SUMMARY EXPERT OPINION
OVERSHADOWING ANALYSIS

PLANNING PROPOSAL
173-179 Walker Street North Sydney

18 October 2017

Figure 2: Comparison of the architects and my shadow projections

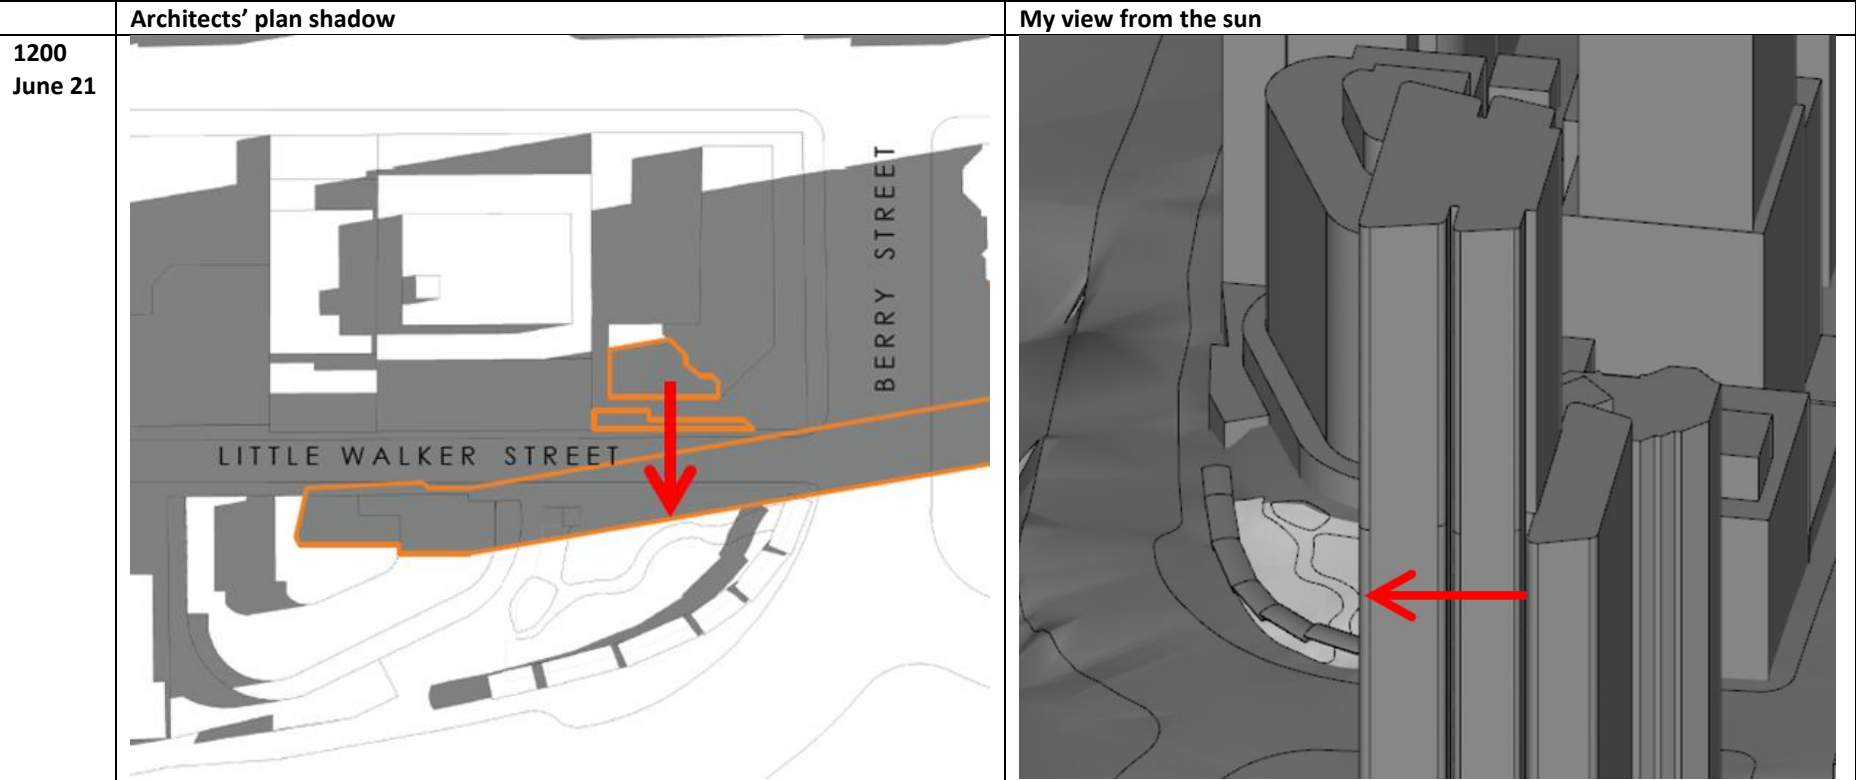
In Figure 2, the arrows indicate a convenient reference point. Note the very small discrepancy in the position of the noon shadow in Dorris Fitton Park. I interpret this small discrepancy in the shadow as caused by a very small difference in the independently set up direction of True North.

In practical terms, the difference between the position of the two shadows translates to between 1 - 2 minutes. In my considered opinion, the discrepancy is negligible and represents accuracy well within acceptable margins for this type of analysis.

After checking the comparison of the shadows at other times on June 21, I conclude that the architects’ overshadowing analysis is sufficiently accurate to be relied on.

Figure 3: Overshadowing potentially outside the North Sydney city core

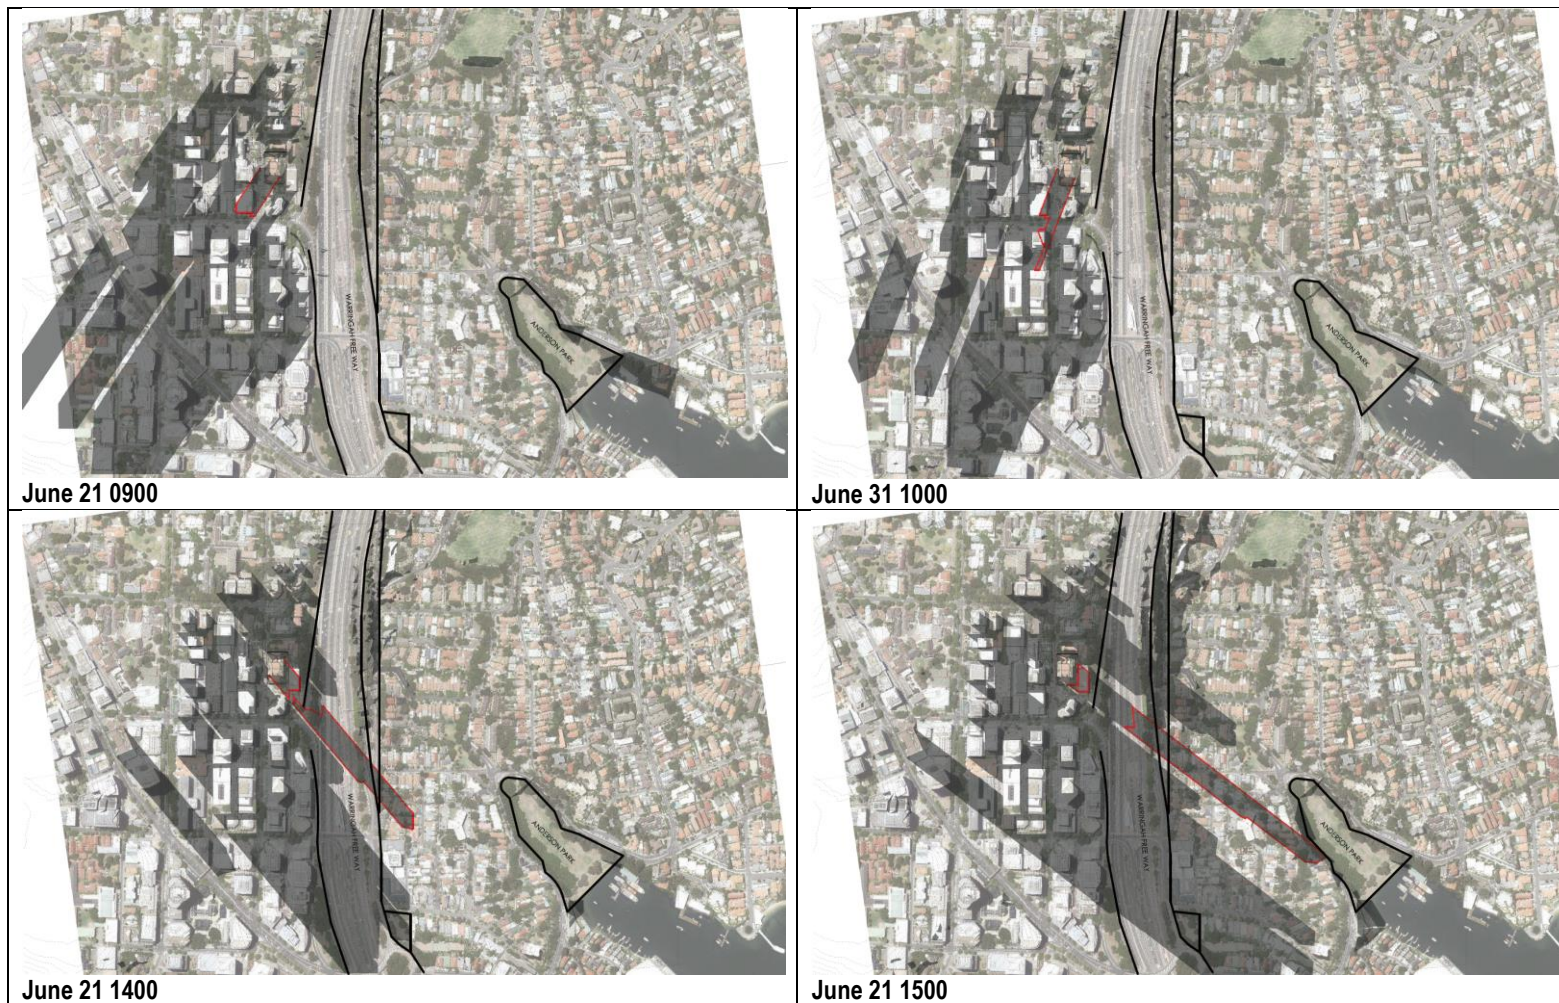
Having established the reliability of the analysis, I reproduced below selected shadows of the North Sydney Centre. I note that additional morning shadow from the Planning Proposal falls entirely within the city centre itself, and mostly on the Warringah Expressway in the afternoon. Additional afternoon shadow does not affect any residential properties to the east of the Expressway, until immediately before 2pm.

For completeness, I focus on the very few properties to the east of the Expressway, affected by additional shadow at exactly 2pm. I note that those properties have unaffected solar access opportunity for nearly 5 hours from 9am. In my considered opinion, therefore, those few minutes of additional shadows do not constitute a breach of the proposed solar access controls.

Figure 4: Overshadowing of Doris Fitton Park

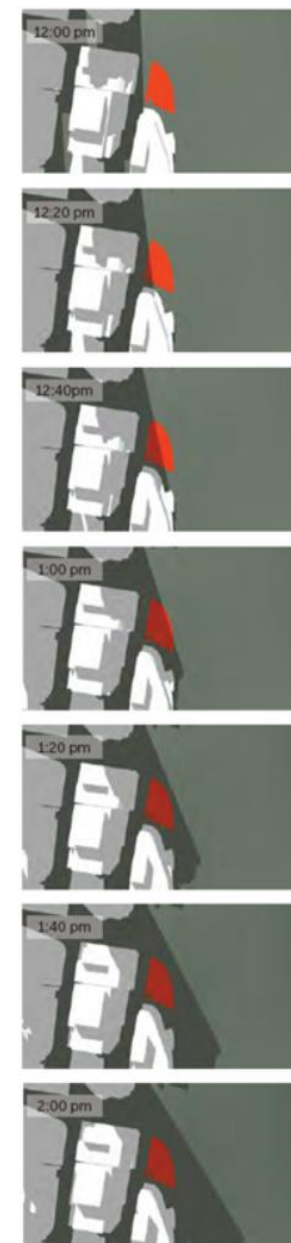
I take from the above that Council is aware that Doris Fitton Park is completely overshadowed by existing buildings after 1pm. Paying regard to the overshadowing impact of the planning proposal, both the architects’ and my analysis confirm that the Park enjoys full solar access from very early morning to nearly 12 noon.

For all intents and purposes therefore, the incremental overshadowing impact of the Planning Proposal is limited to varying degree between just before 12 noon and 1pm. The 'X-ray' views from the sun in Figure 4 make clear that from just after 1230pm, the major share of the overshadowing impact on Dorris Fitton Park is in fact the existing shadow from the Century Plaza at 80 Berry Street – and that by 1pm, shadow that can be attributed to the subject Planning Proposal is so small as to be negligible.

Figure 5: Relative share of overshadowing impact from Planning Proposal

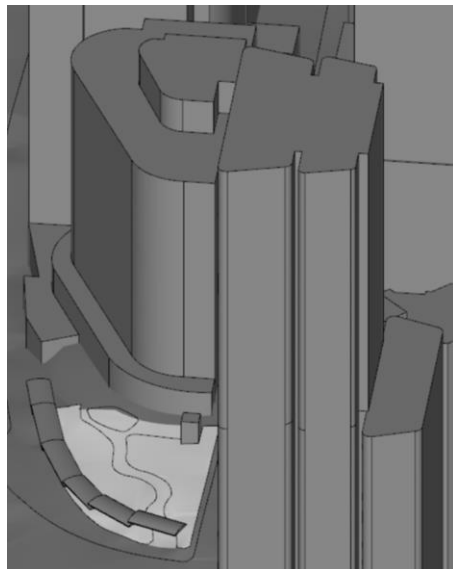
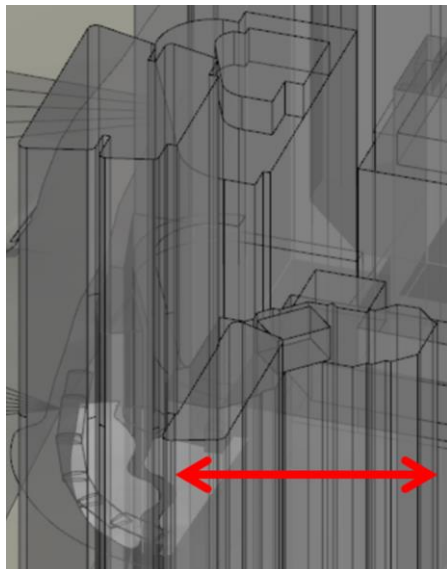
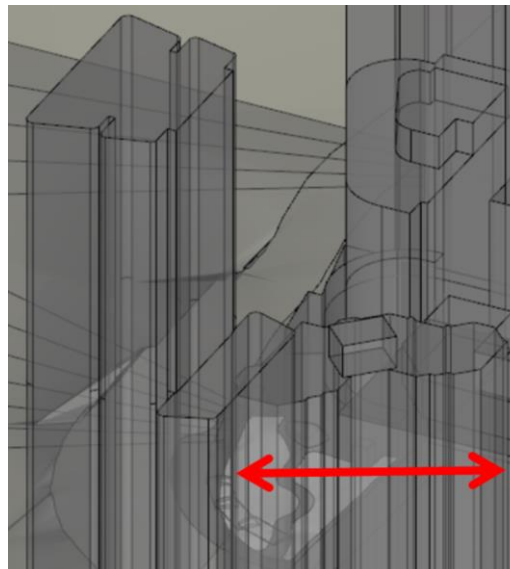
No shadow at 1150

The arrows show the portion of existing shadow attributable to Century Plaza at 80 Berry St.

Figure 6: Height reduction required to eliminate shadow at 1230pm

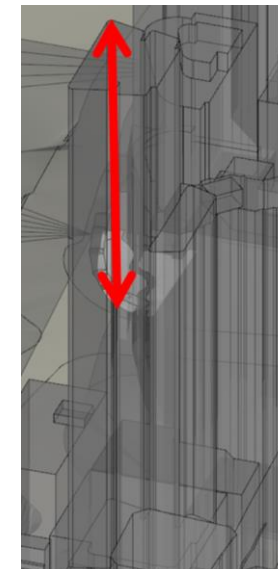
Using the same technique, Figure 5 identifies *what would be the necessary reduction in height* of the Planning Proposal, in order to eliminate the relatively small additional overshadowing impact on Dorris Fitton Park. I estimate the required height reduction as over 40% of the proposed height. *To my mind this is a clearly disproportionate limitation on the development potential of the subject site, to deal with the relatively small overshadowing impact.*
